ECE/TRANS/WP.29/GRE/2006/47
21 July 2006

PROPOSAL FOR DRAFT AMENDMENTS (REVISION 1) TO REGULATION No. 113

(Headlamps emitting a symmetrical passing beam)

Submitted by the expert from the International Motorcycle Manufacturers Association (IMMA)

Figure C

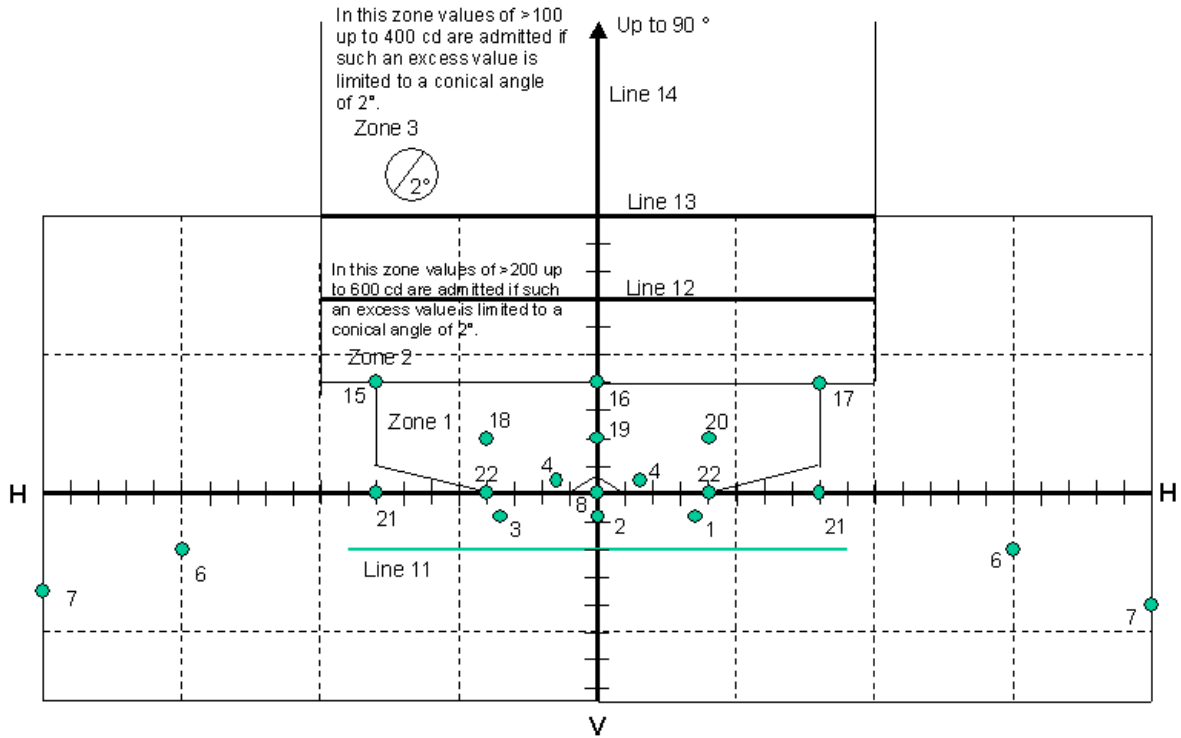
MEASURING SCREEN
for Class C, **D and E** headlamps
(Dimensions in mm with screen at 25 m distance)

Note: The luminous intensity of zones 2 and 3 above are not applied to Class E.
